## **CASE 863-V-16**

*PRELIMINARY MEMORANDUM*

**Request: Authorize the following Variance in the R-1 Single Family Residence Zoning District for an existing residence and existing garage and a proposed patio and a proposed detached shed and unauthorized earth fill, all located in an existing storm water drainage easement:**

**Subject Property: Lot 100 in Rolling Hills Estates V Subdivision in Section 12, Township 20 North, Range 7 East of the Third Principal Meridian in Mahomet Township, and commonly known as the residence at 2312 Pheasant Ridge Road, Mahomet.**

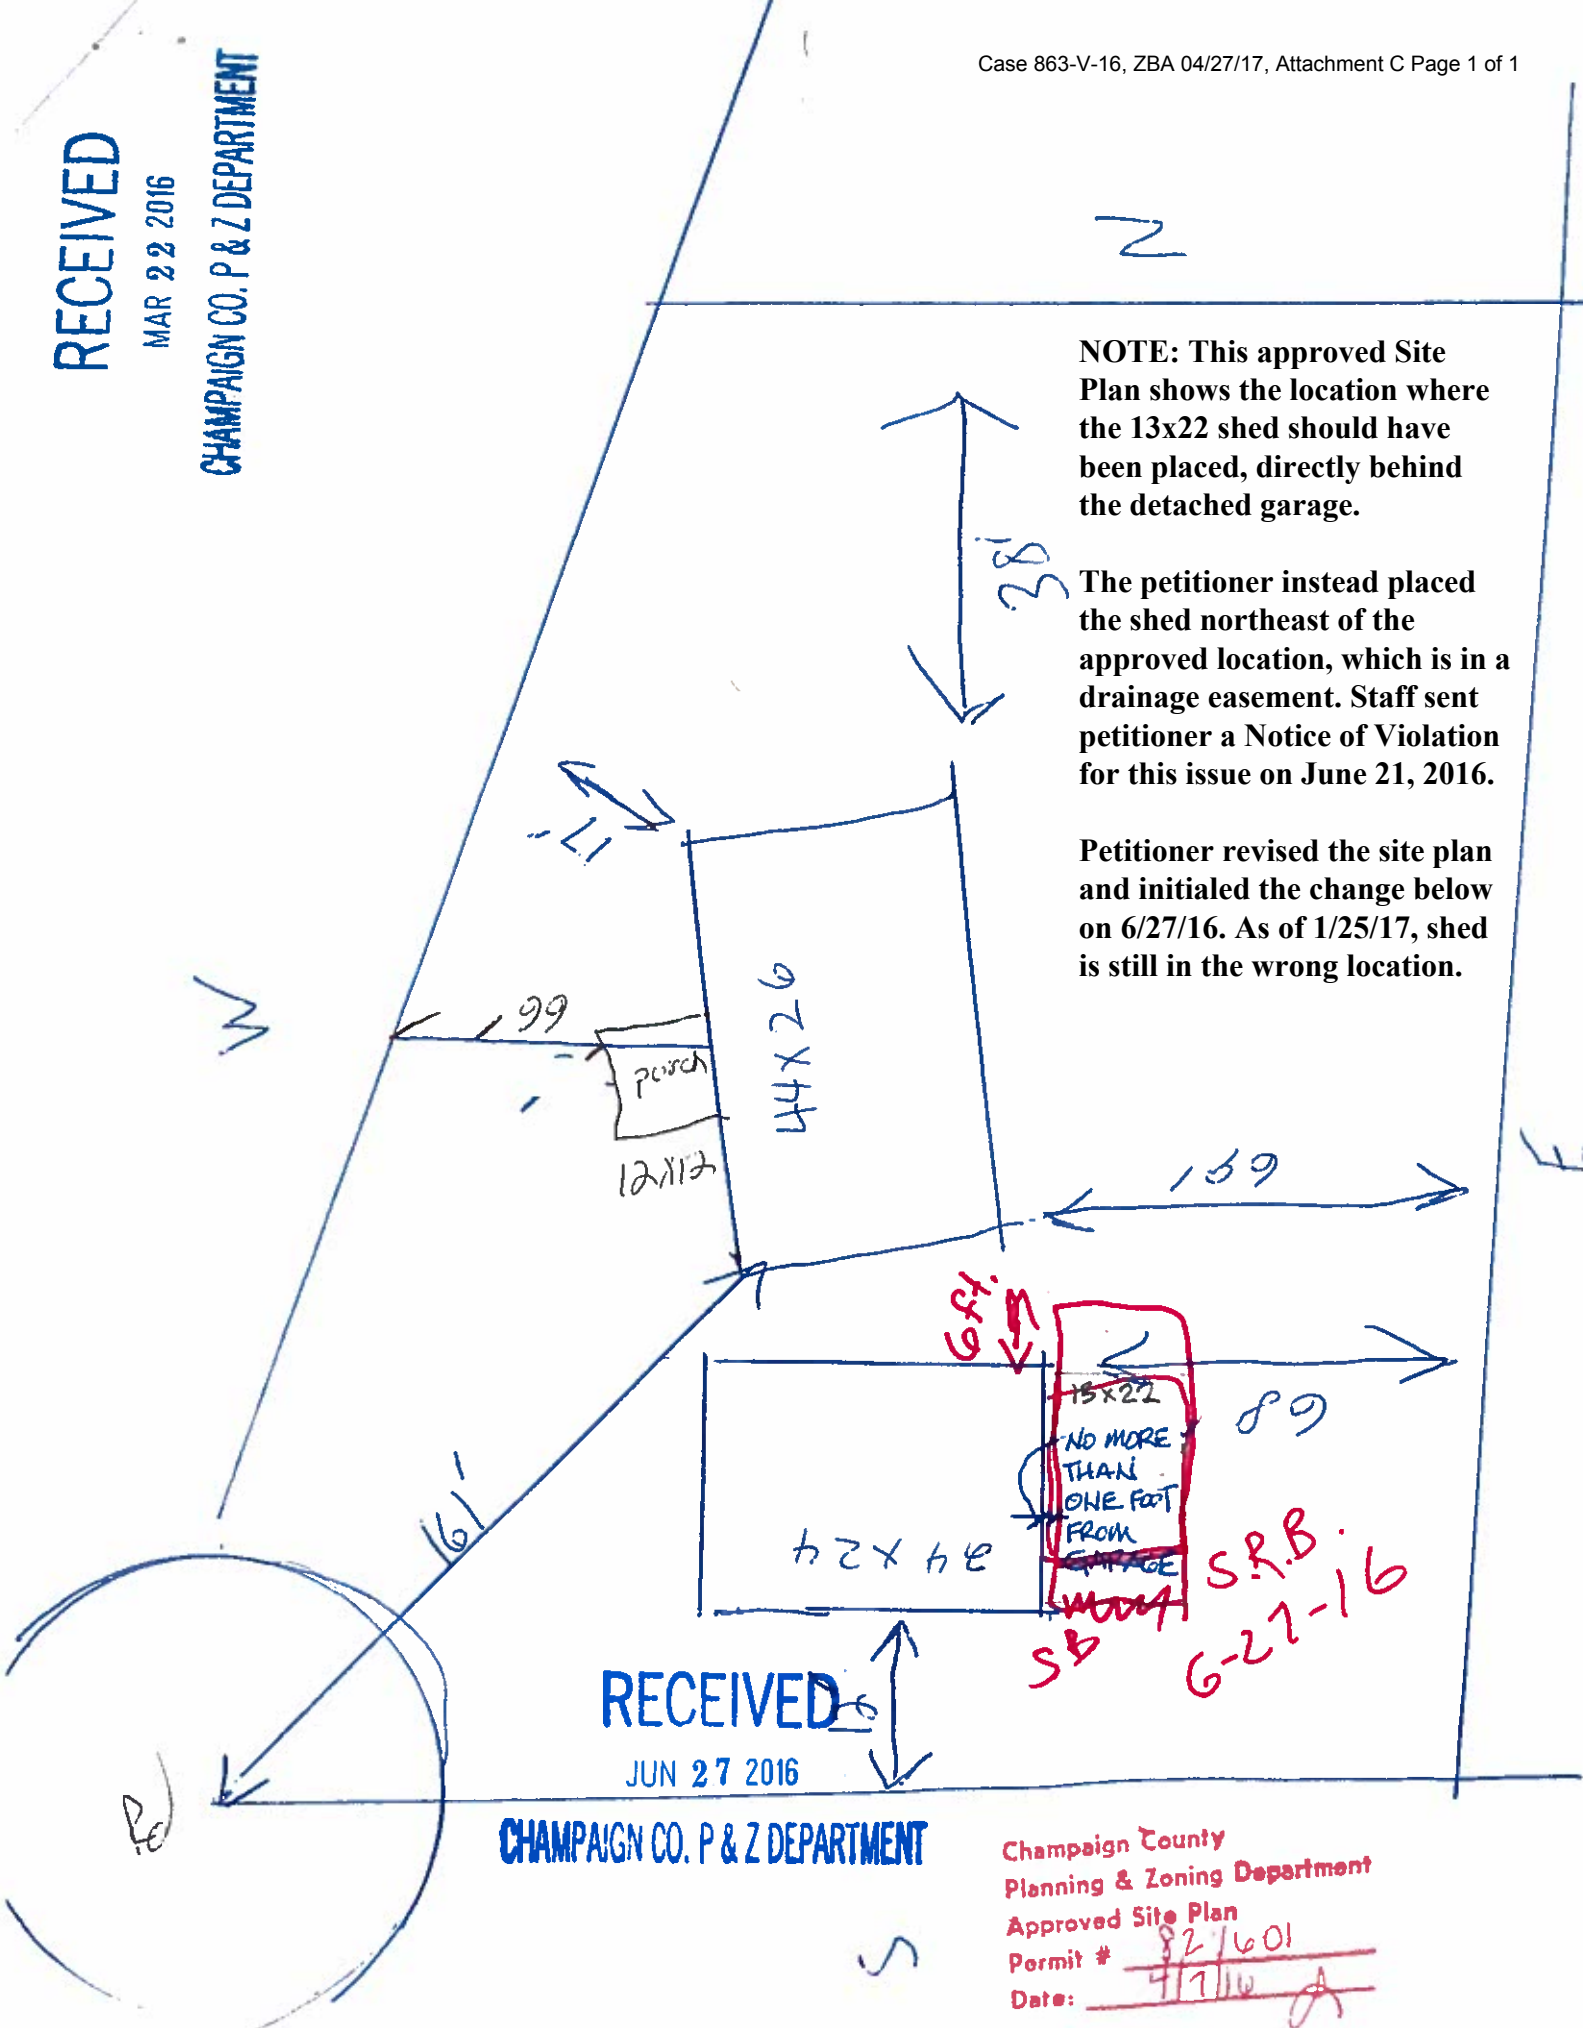
NOTE: This approved Site Plan shows the location where the 13x22 shed should have been placed, directly behind the detached garage.

Petitioner revised the site plan and initialed the change below on 6/27/16. As of 1/25/17, shed is still in the wrong location.

LIMITED TOPOGRAPHIC SURVEY

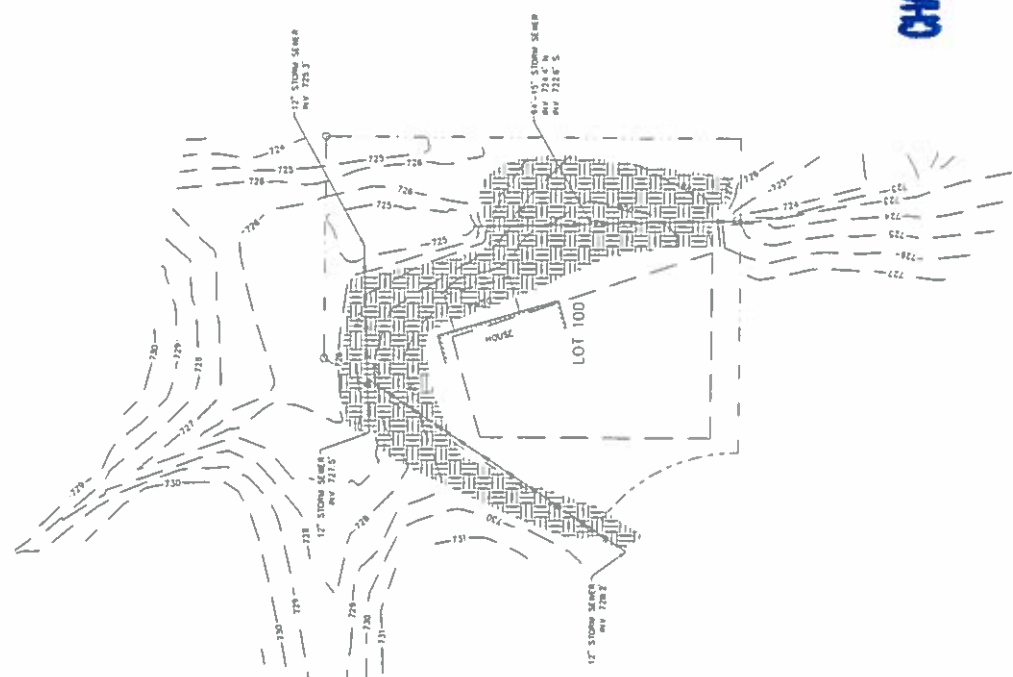
5. Your topographic information indicates that fill has been added to Lot 99 and I wonder if the owner of that lot approved the fill? If the owner of Lot 99 did approve that fill it will behoove Mr. Blakeney to provide some documentation of that approval and if the owner did not approve the fill then I recommend that the fill be removed.

6. I will also ask Mr. Blakeney to have you provide an accurate drawing illustrating the distance from the northwest corner of the dwelling to the northwest lot line. The minimum required separation is 10 feet but anything less than 10 feet must be approved by variance.
